**SOIL/SITE EVALUATION  
for ON-SITE WASTEWATER SYSTEM**

MAP# 2006-713  
SHEET 2 OF 2  
COLONIAL HILLS SUBDIVISION

### PRELIMINARY PLOT PLAN

PROPERTY OF: RBC HOMES, INC.  
ADDRESS: COLONIAL HILLS DRIVE

MAP# 2006-713  
SHEET 2 OF 2  
COLONIAL HILLS SUBDIVISION

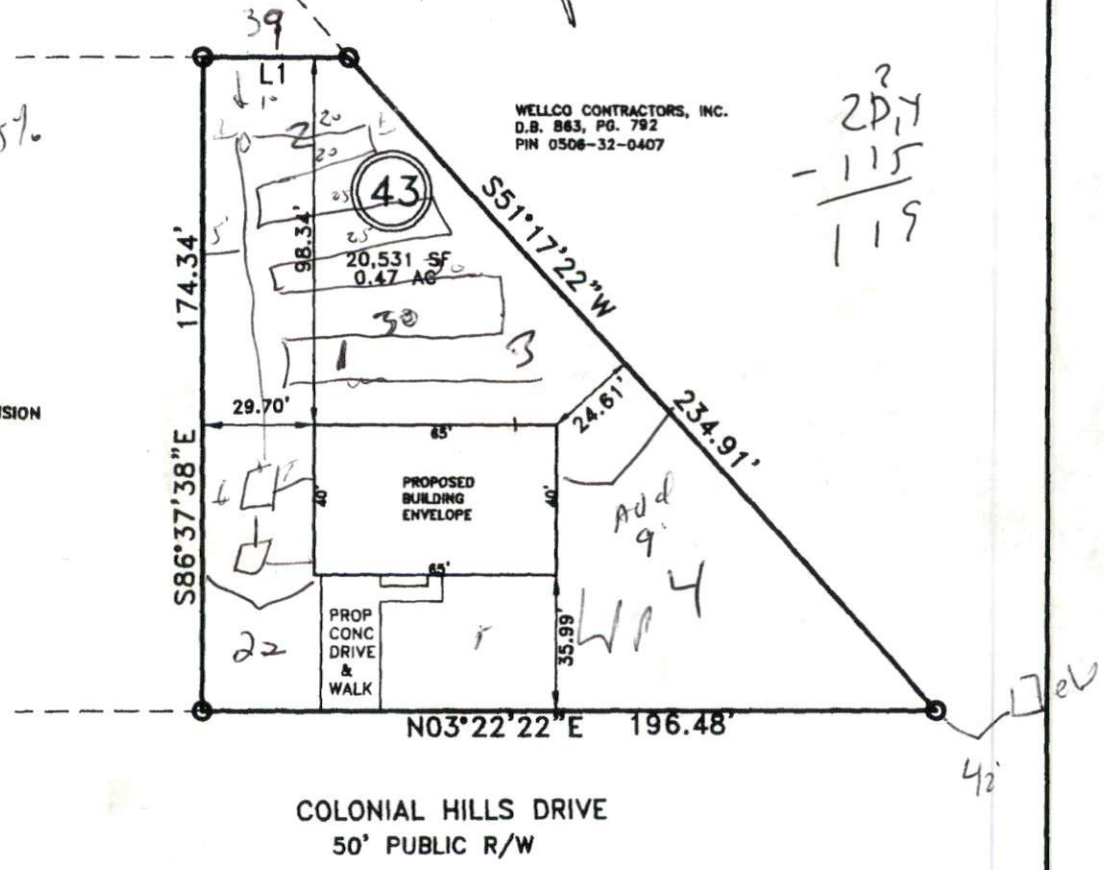
*make n-h on chdr*

*Plant location*

*Move house over*
